# Final Drainage Report

## McGehee Tract El Paso County, Colorado

April, 2021

PCD No. SF2011

**MCGEHEE SUBDIVISION**  
DRAINAGE PLAN  
EXISTING CONDITIONS

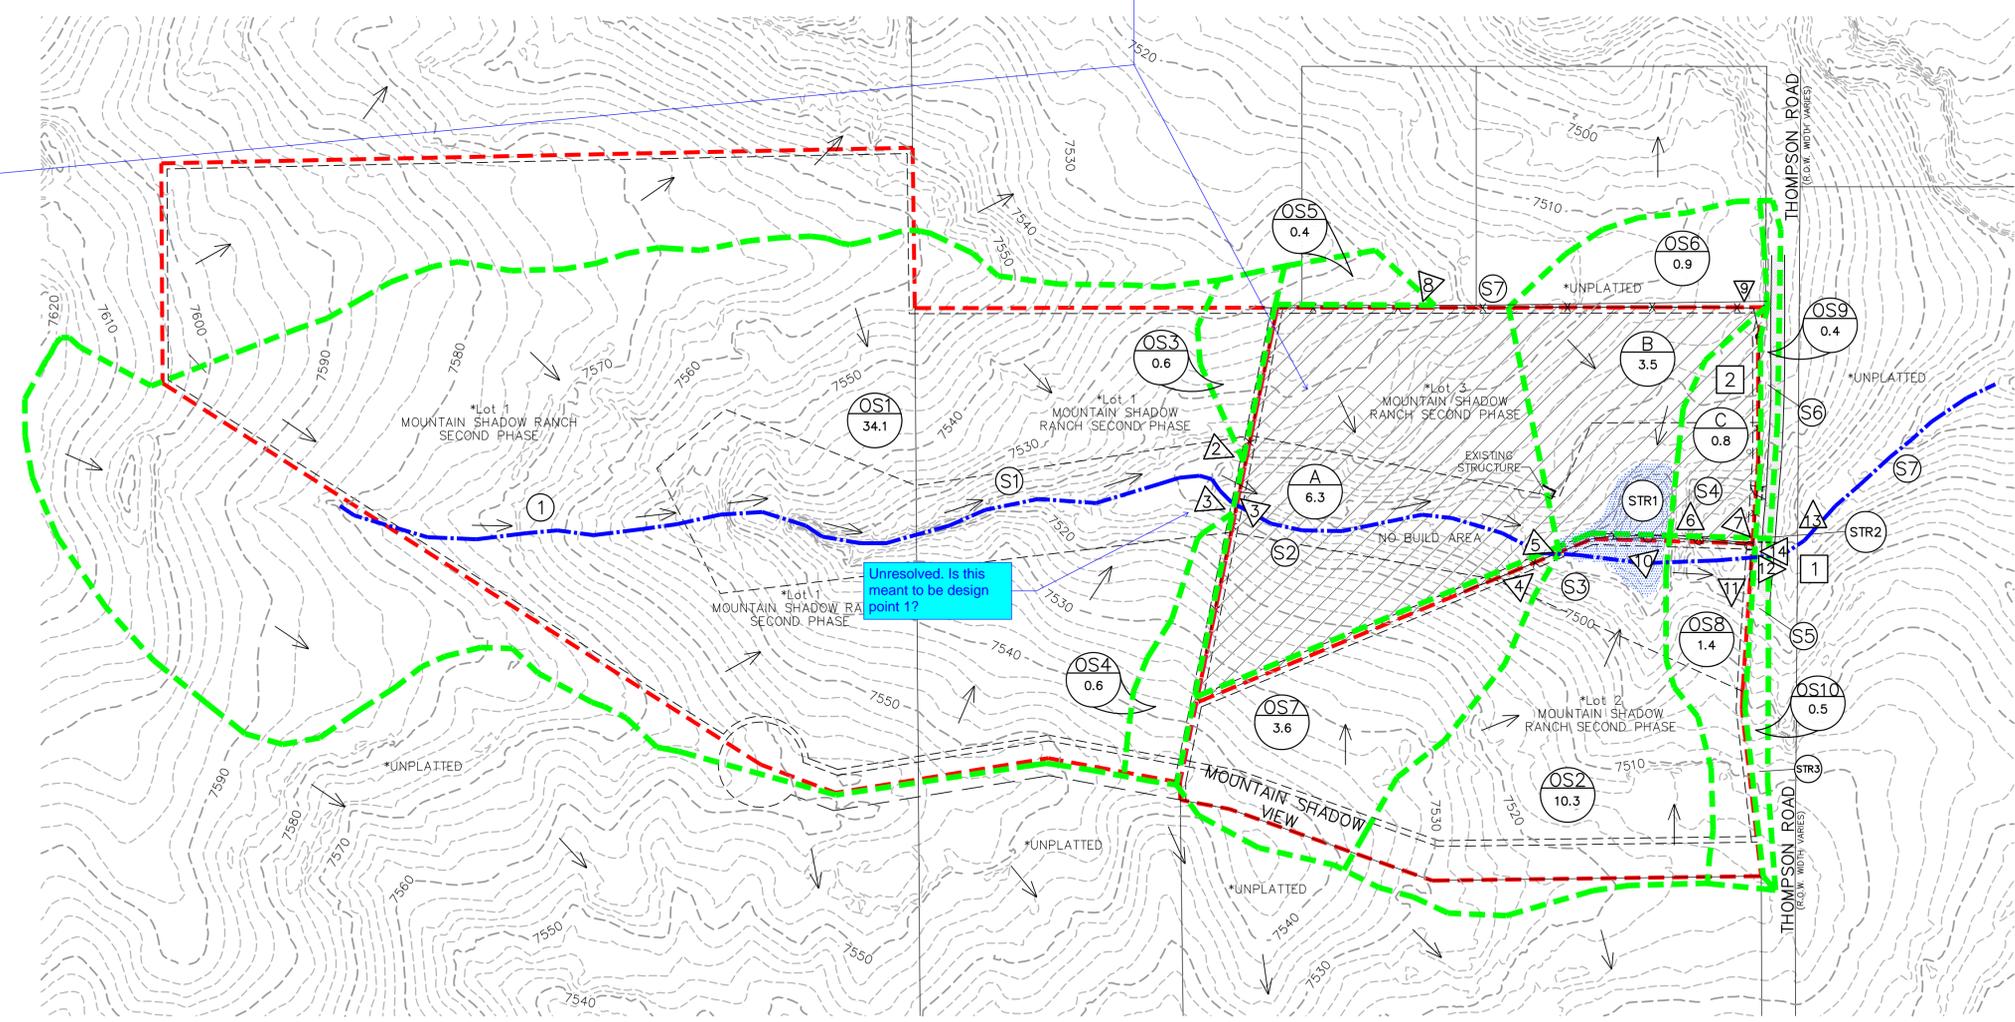
Unresolved. Design point 3 should show cumulative flows from OS1, OS3, and OS4.

Unresolved. Hatching is labeled as no build but is covering entire site. Update both drainage maps.

Unresolved. Is this meant to be design point 1?

**MCGEHEE SUBDIVISION DRAINAGE PLAN DEVELOPED CONDITIONS**

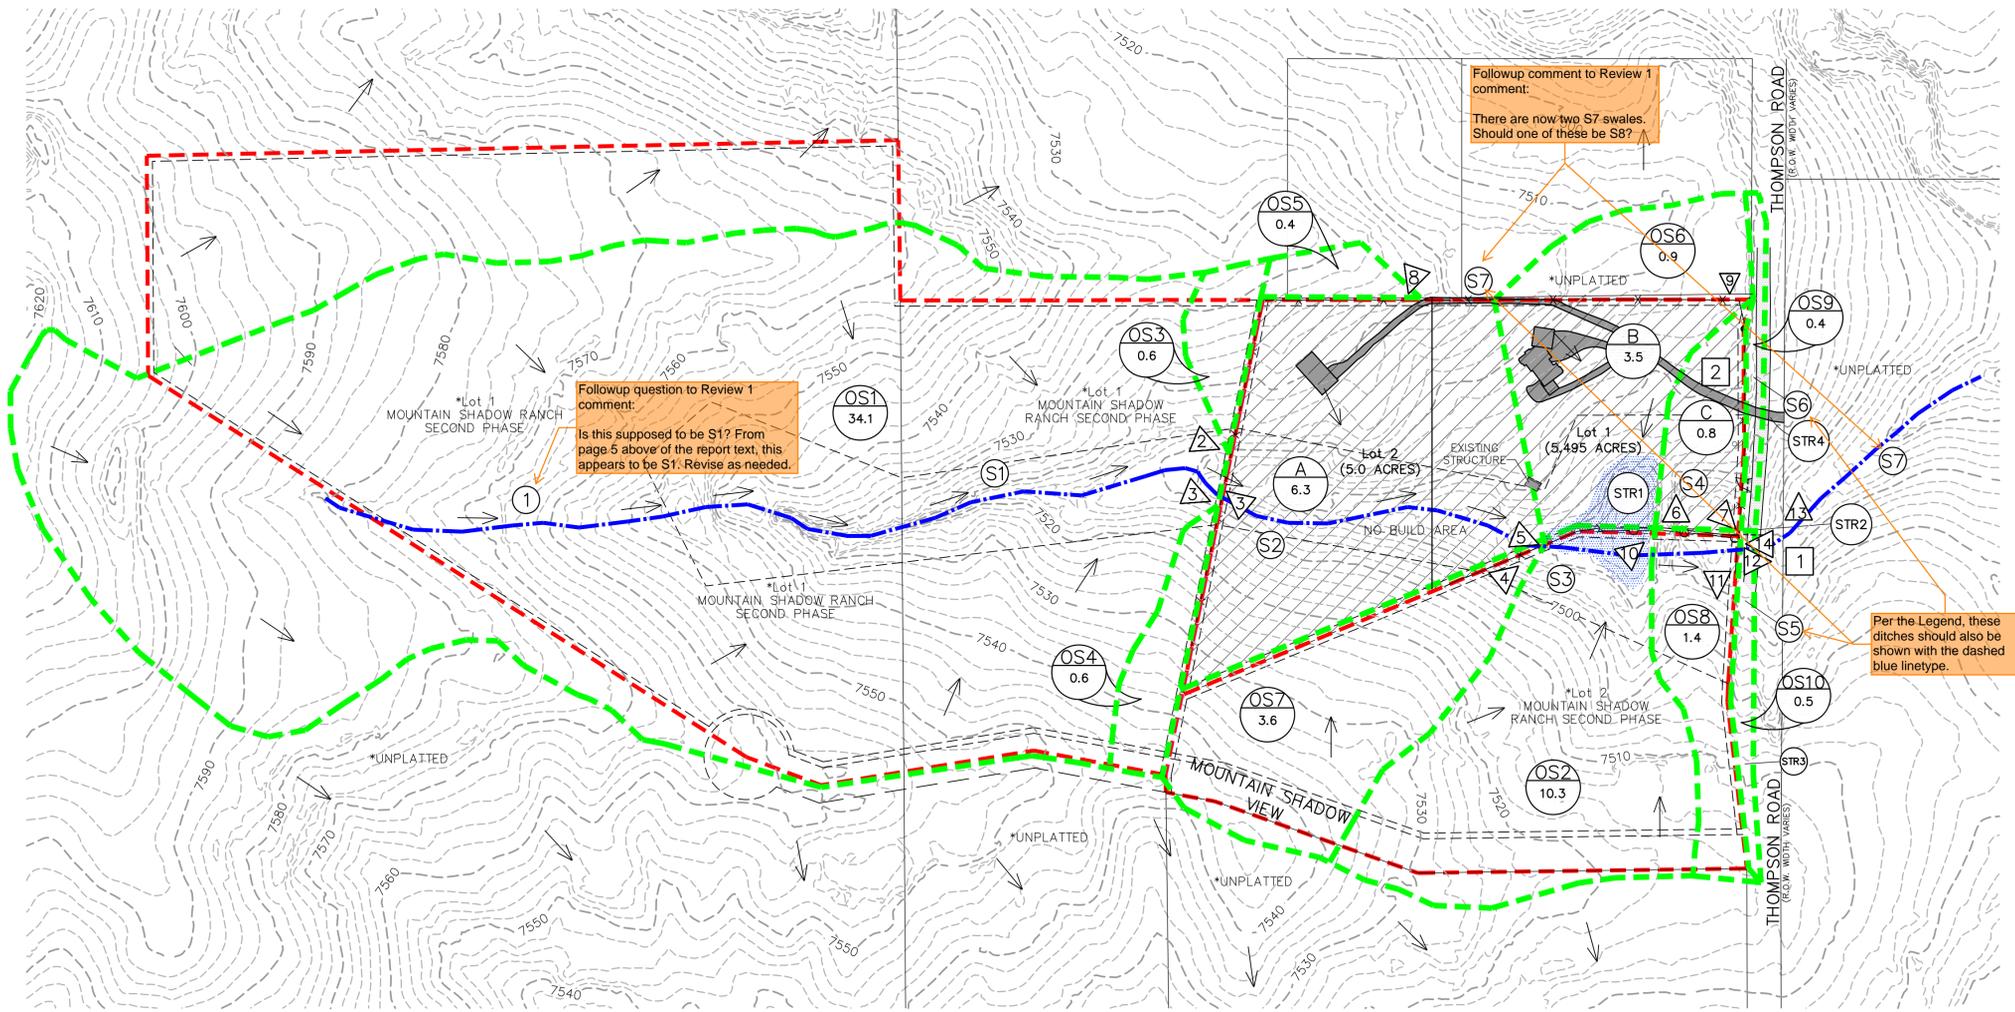
Review 1 Comment: Revise to be in S1, S2... format for clarity (so it matches map below)
